Cricklade Town Council's Planning, Conservation and Transport Committee 1st June 2026

PL/2026 /02252	Site: Avenham House, Gas Lane, Cricklade, SN6 6BY Proposal : Erection of close board timber boundary fence along northern boundary, to a height of 2.4m or as close to it as permitted (retrospective) Applicant: Ian Dodsworth Closing Date: 2 nd June 2026
---------------------------	---

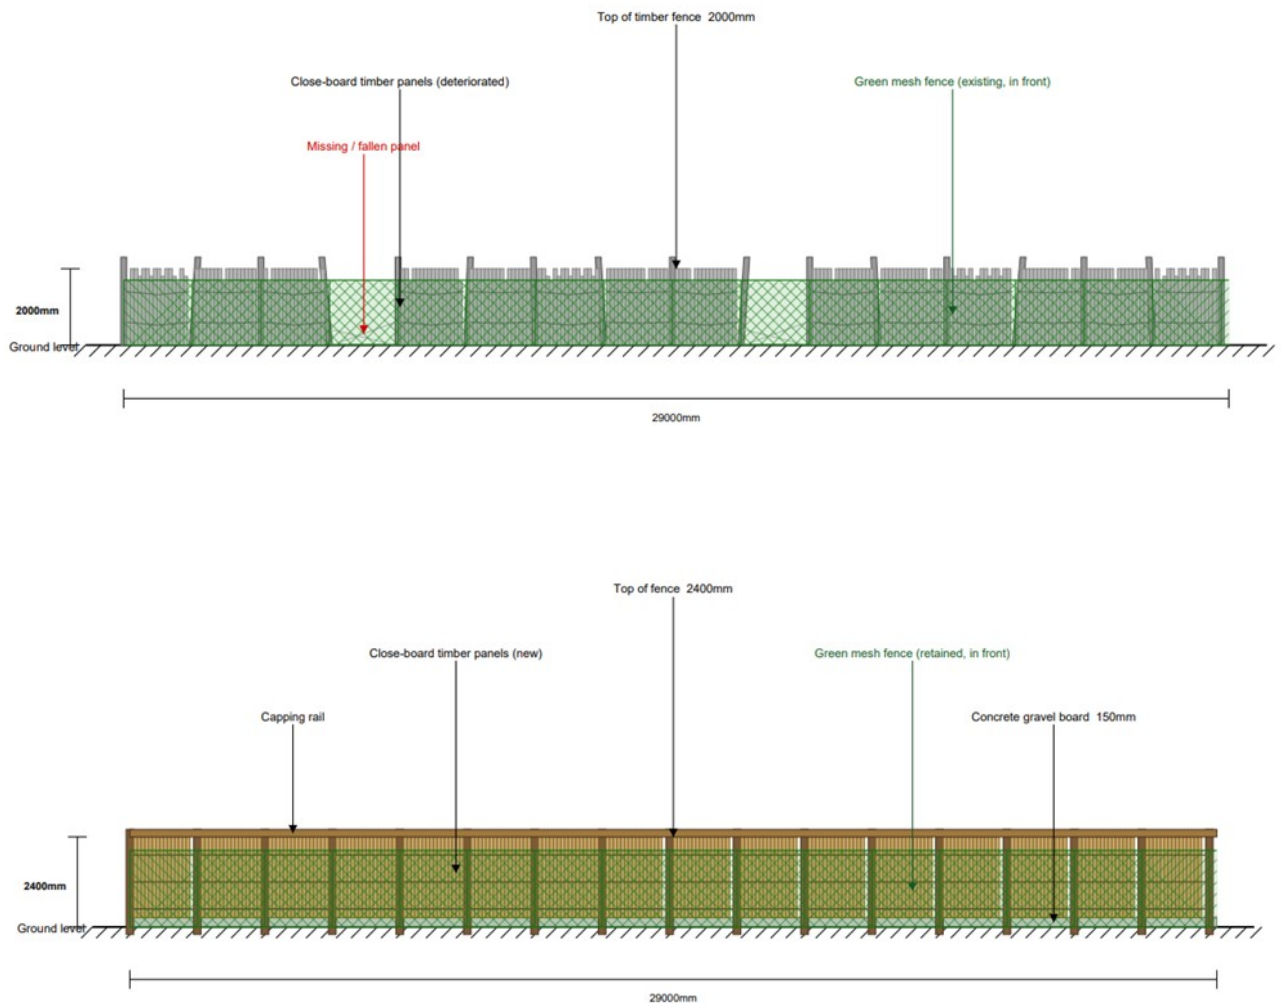
Recommendation was to approve but Members discussed the application and VOTED to OBJECT. There is a precedent to keep fence heights to 2 metres. There does not appear to be any planting done to provide a soften screen between the green fence and the new

high fence. However, it appears there would be difficulties accessing the gap to maintain any future planting anyhow.

Previously and recently, WC Enforcement have been reported to on other resident's fences in Cricklade that were over the permitted 2 metres and this is well over 2 metres. The applicant should restrict it to the allowable height of 2 metres as the current fence appears very overbearing for pedestrians walking through.

Those houses opposite with brick walls are at the height of 6 foot not 8ft as alluded to in the applicant's report.

The area is not a renowned area for anti-social behaviour that CTC are aware of and presumably whatever height the fence is would not prevent someone from throwing small objects over. The house has always been next to a public footpath with the fence backing onto their garden patio.

8 members voted to OBJECT on the grounds that the rules are 2 metres and if need to be higher the applicant should have gained prior permission from WC.
